TISDALE WEIR REHABILITATION AND FISH PASSAGE PROJECT

Final Environmental Impact Report

Prepared for
California Department of Water Resources

August 2021

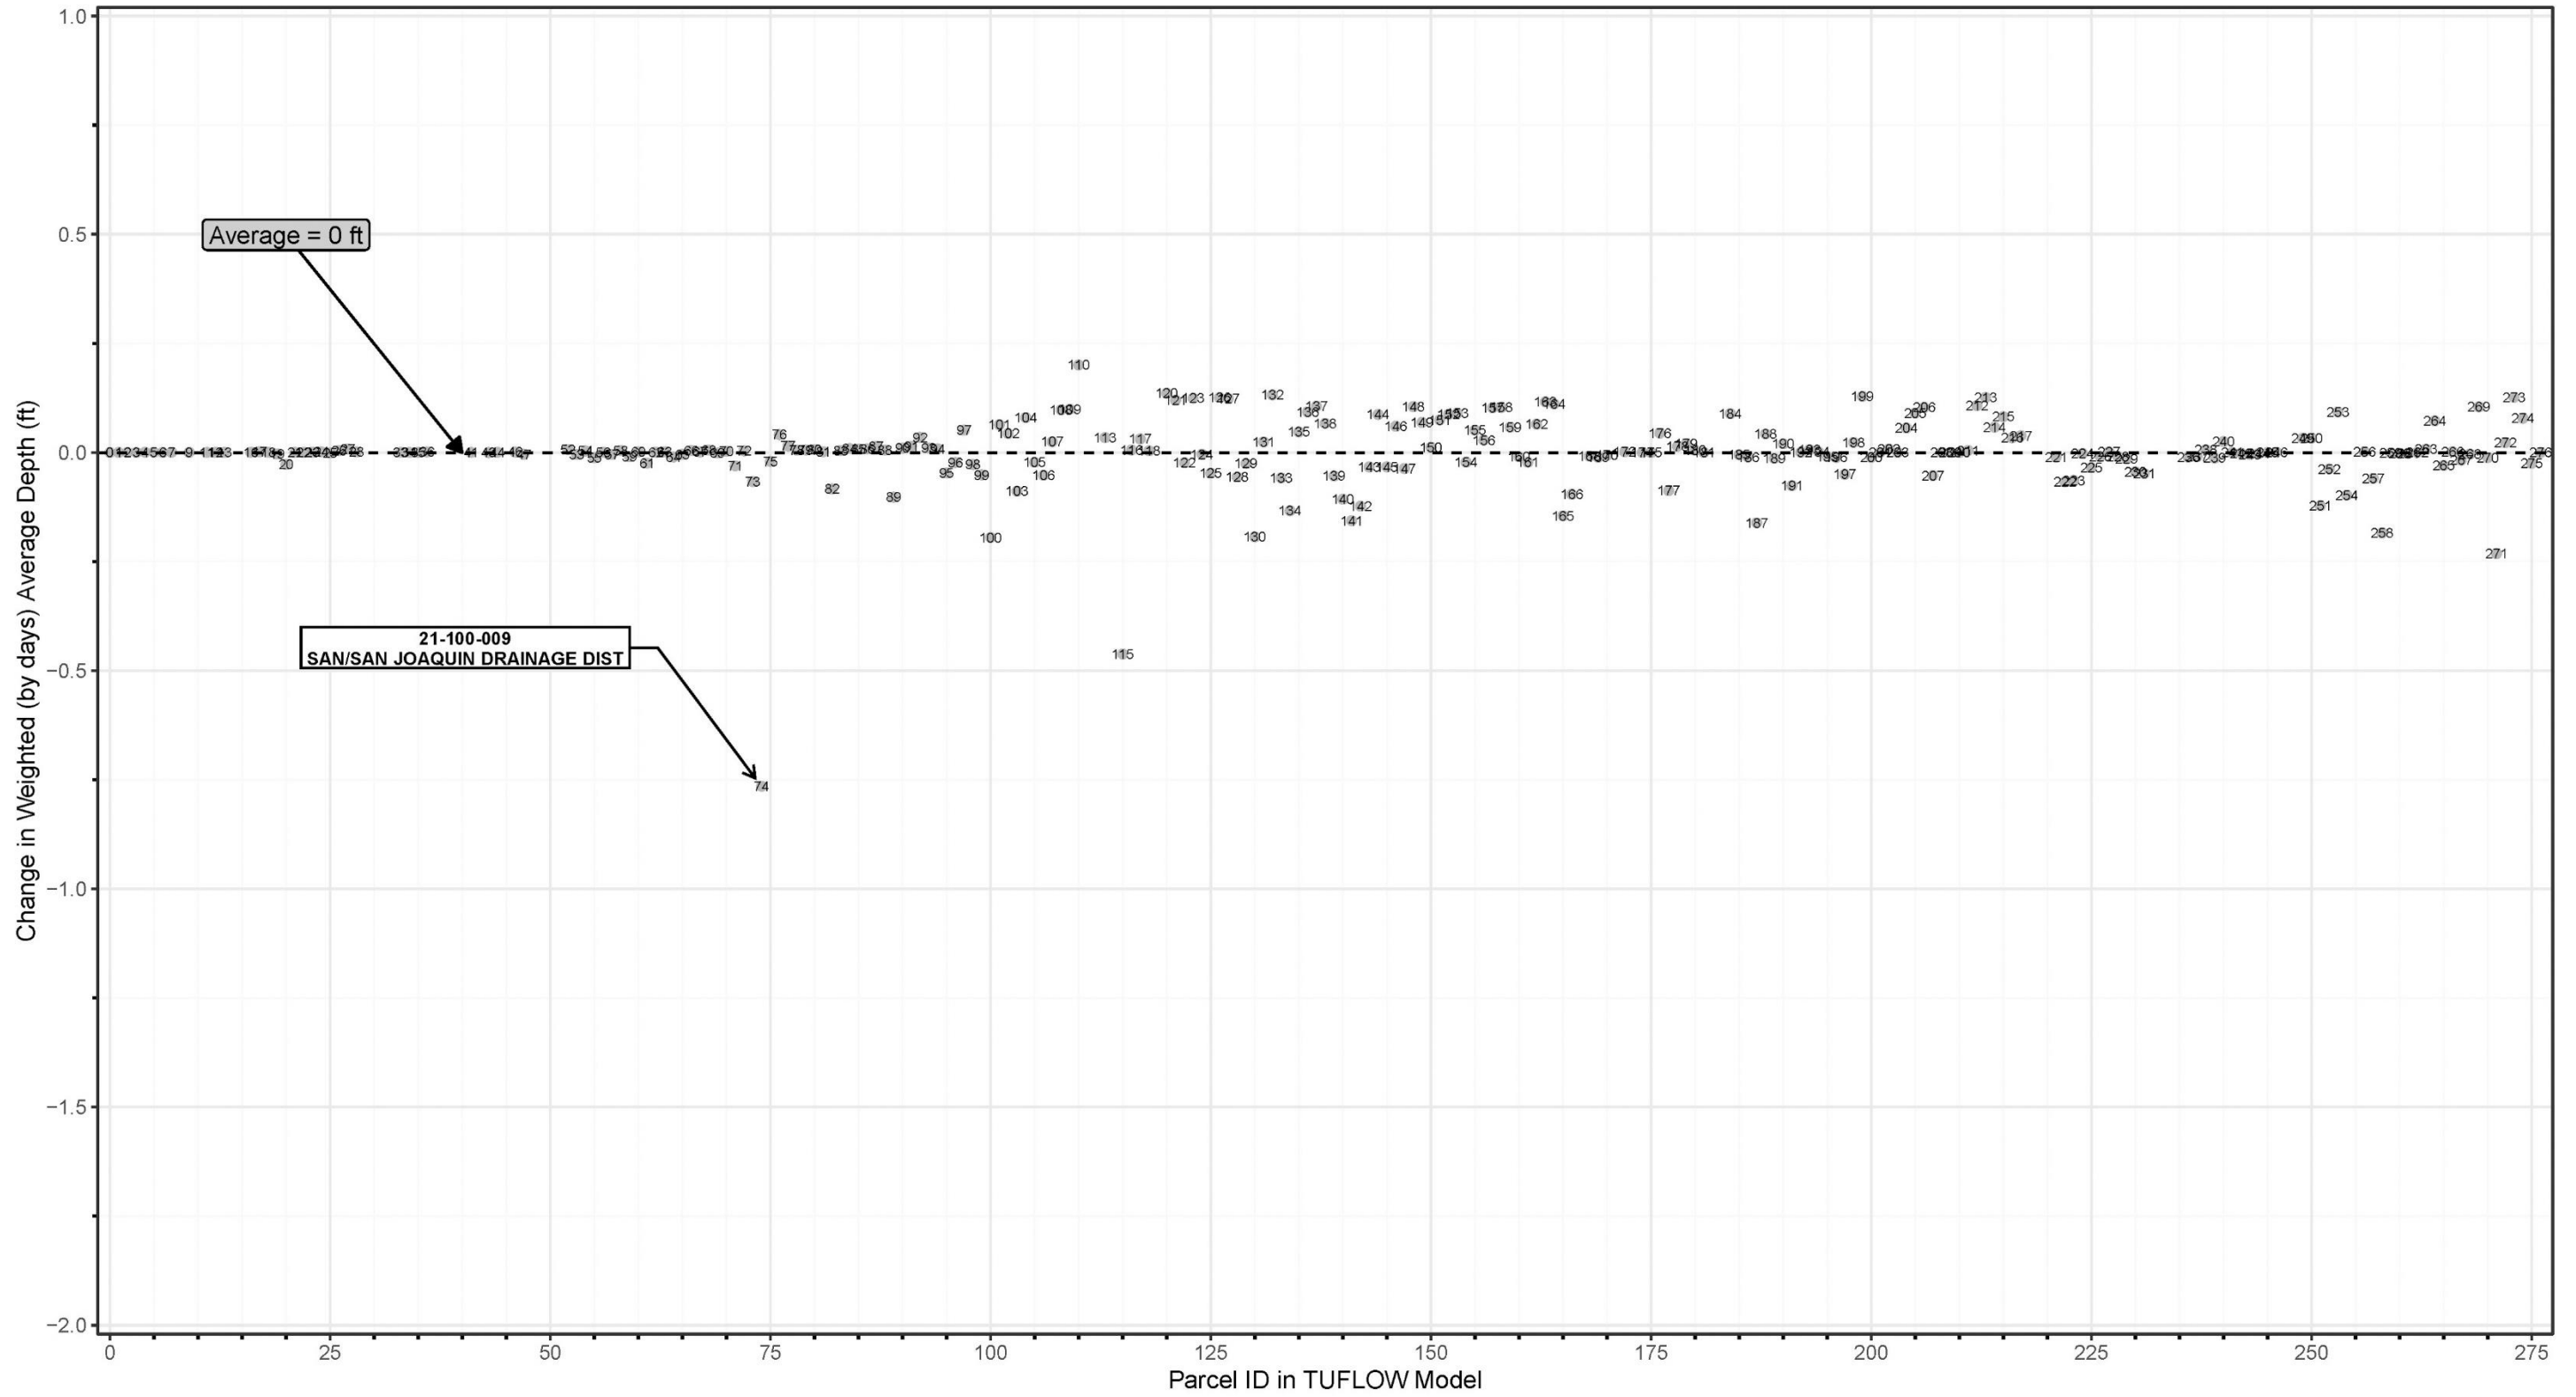
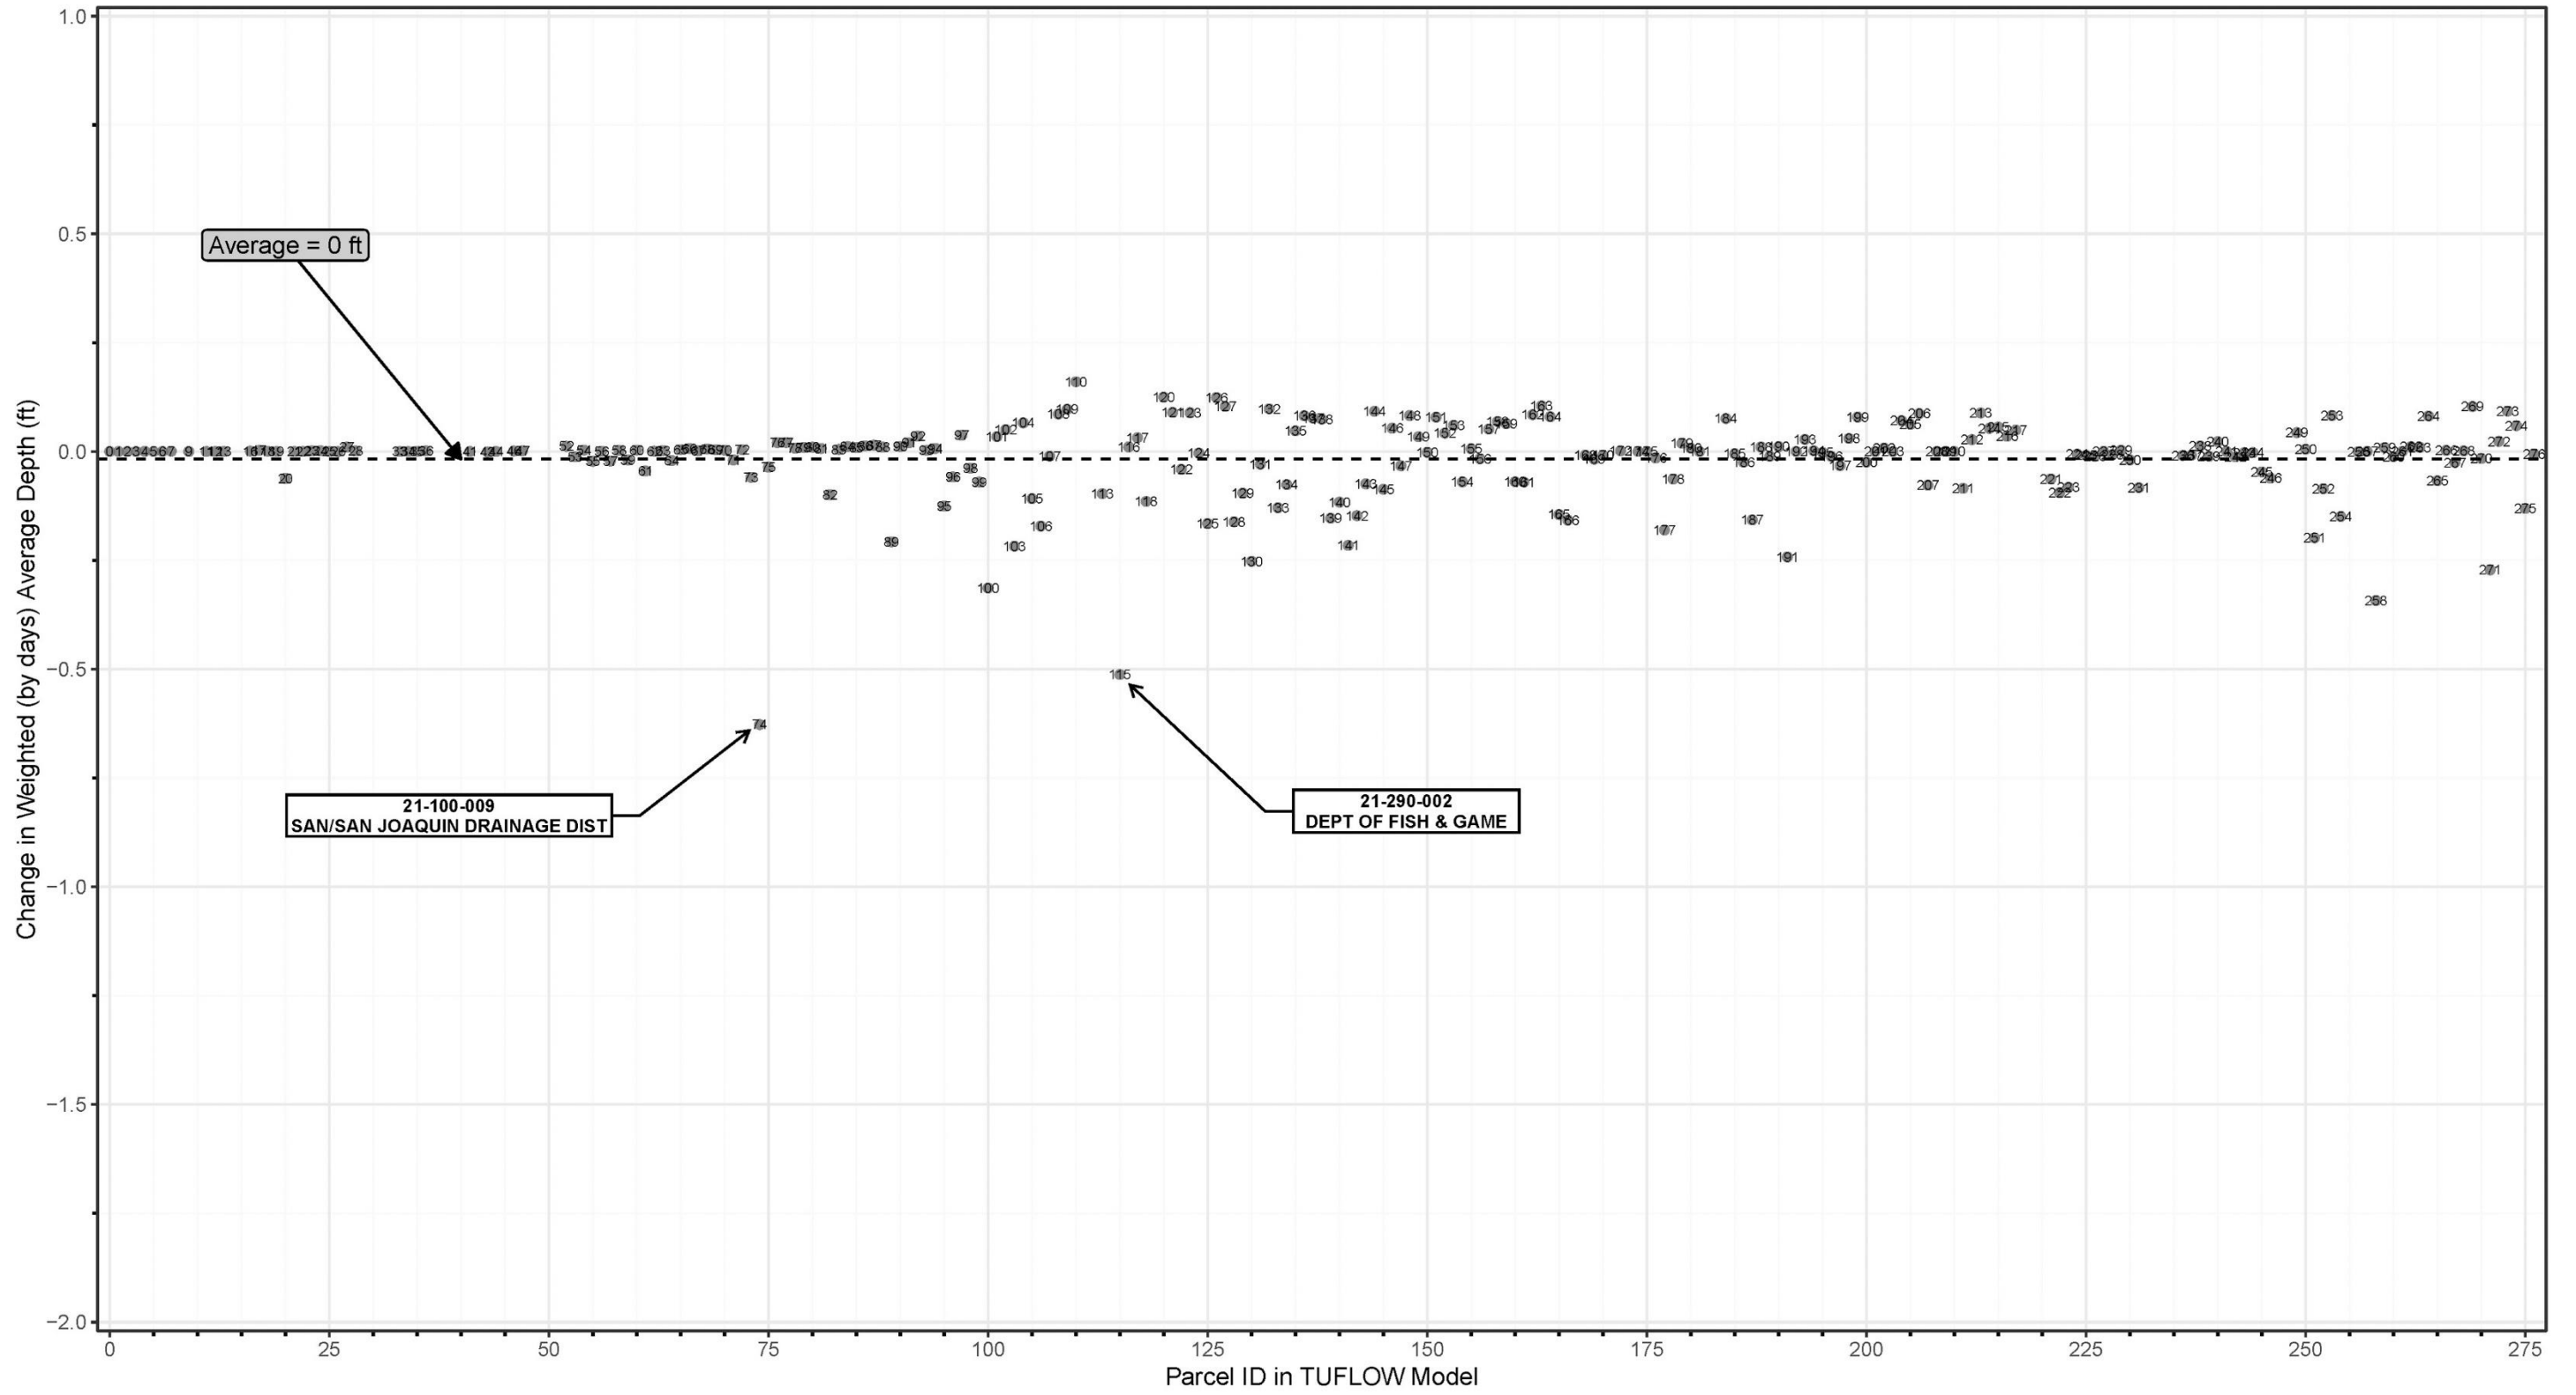
Figures 13 through 24 in Attachment E of this FEIR present the average changes in water depth, by water year type, for each parcel in the Sutter Bypass and, as shown, the predicted changes in water depth are very minor. As evident in Figures 13 through 24, the predicted increases in depth for wet days and dry days that are greater than approximately 0.5 feet are for parcels that belong to the Sacramento/San Joaquin Drainage District or the California Department of Fish and Wildlife (CDFW). In addition, Attachment F of this FEIR provides the change in the number of wet days for the waterfowl season for all water years and parcels in the Sutter Bypass.
